## Riley Purgatory Bluff Creek Watershed District Permit Application Review

**Permit No:** 2023-049

**Project:** Pearson: Proposed construction of a new home on Lot 1 of the Berrospid development permitted under RPBCWD 2019-051.

**Location:** 351 Joanna Drive, Chanhassen, MN 55317

# CERTIFICATE OF SURVEY

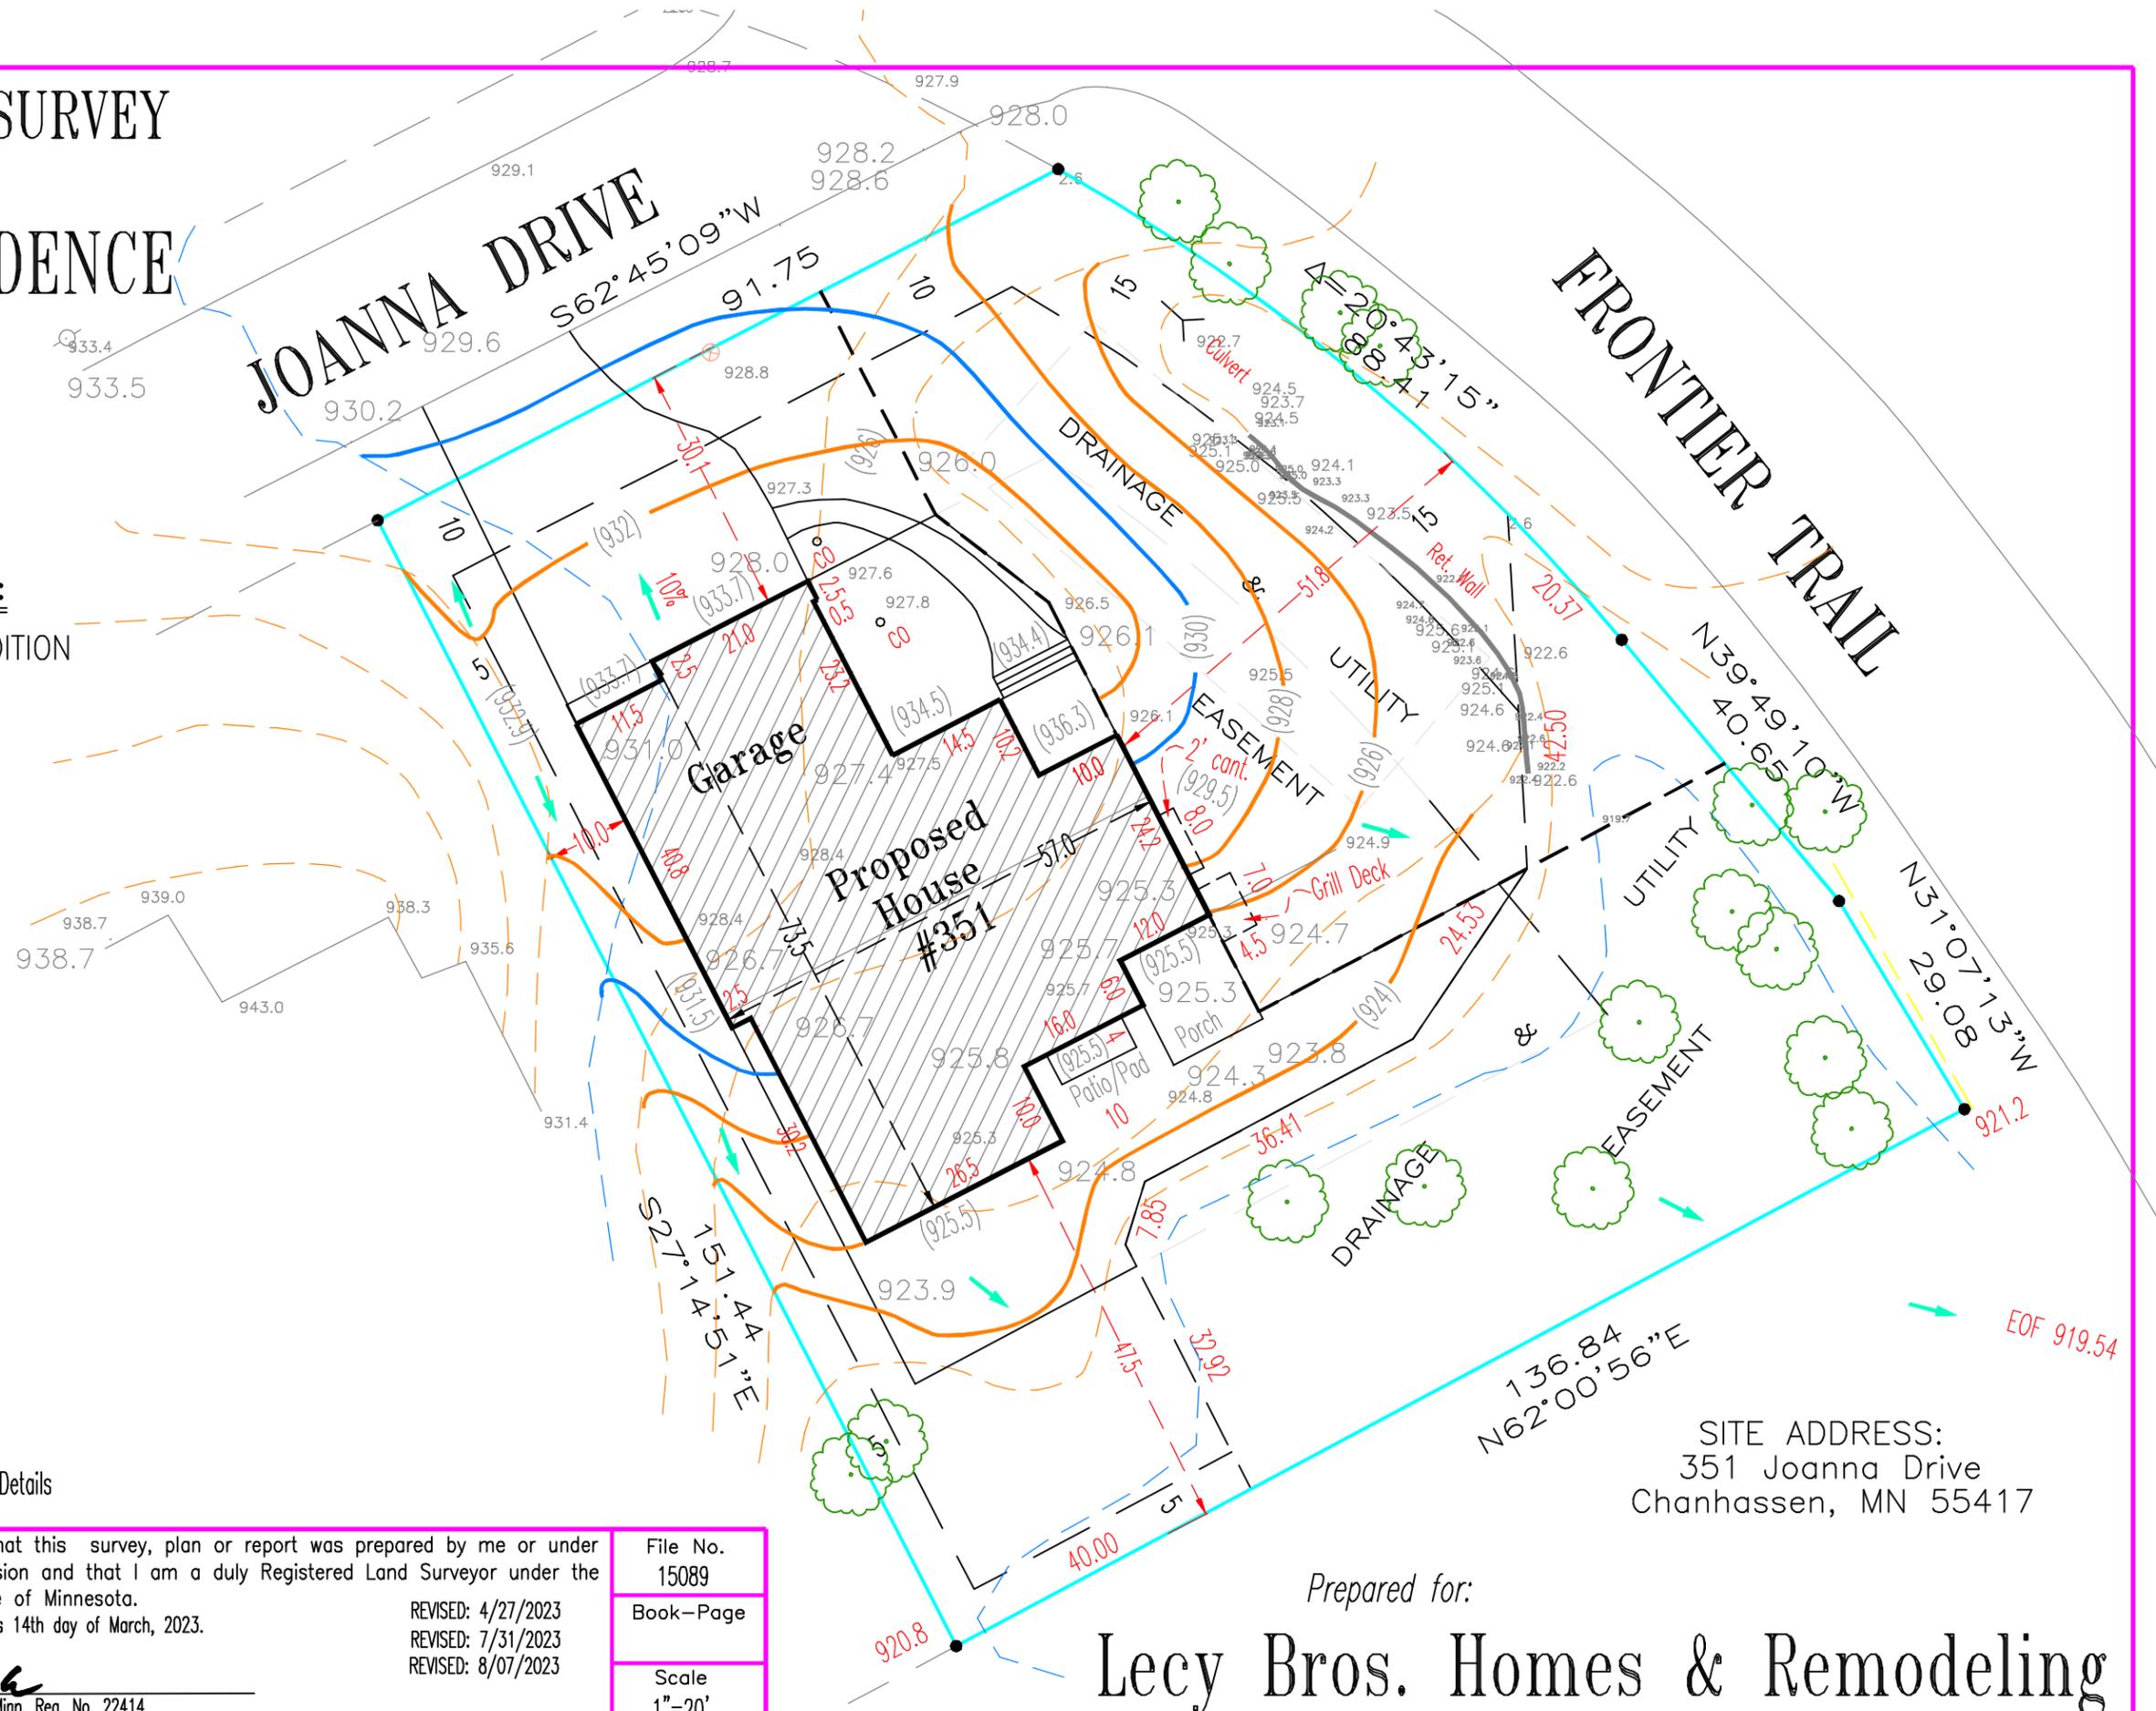
RPBCWD previously approved the project with a low floor elevation for the home on Lot 1 of 927.0 (2 feet above the computed 100-year) in the underground stormwater-management facility constructed under permit 2019-051. The stormwater facility configuration includes a primary and secondary outlet. Because review of underground system constructed under permit 2019-051 and the stormwater modeling submitted for the application shows the secondary outlet pipe is utilized during a 2-year event, the secondary outlet cannot be considered an emergency overflow. Typically the emergency overflow is only accessed/used for events larger than the 100-year storm to reduce the likelihood of water levels significantly exceeding the 100-year high-water level. The outlet configuration and grading is such that if water reaches the 100-year high water level within the materials around the underground stormwater facility as the modeling suggests, the water would nearly reach the ground surface and indicates that the emergency overflow would be elevation 925.0 feet (i.e., the ground surface). Because the low floor elevation of the proposed home is 1-foot above the emergency overflow of the adjacent stormwater management facility as summarized below, the proposed project is in conformance with Rule J, Subsection 3.6a.

| Location Riparian to Stormwater Facility | Low Floor Elevation (LFE) of Building (feet) | 100-year Event Flood Elevation Stormwater Facility (feet) | Freeboard to 100-year Event (feet) | Emergency Overflow (EOF) of Stormwater Feature (feet) | Required Separation to between LFE and EOF (feet) |
|--|--|---|------------------------------------|---|---|
| Lot 1                                    | 926.0  | 925.0   | 1.0                                | 925.0   | 1.0   |
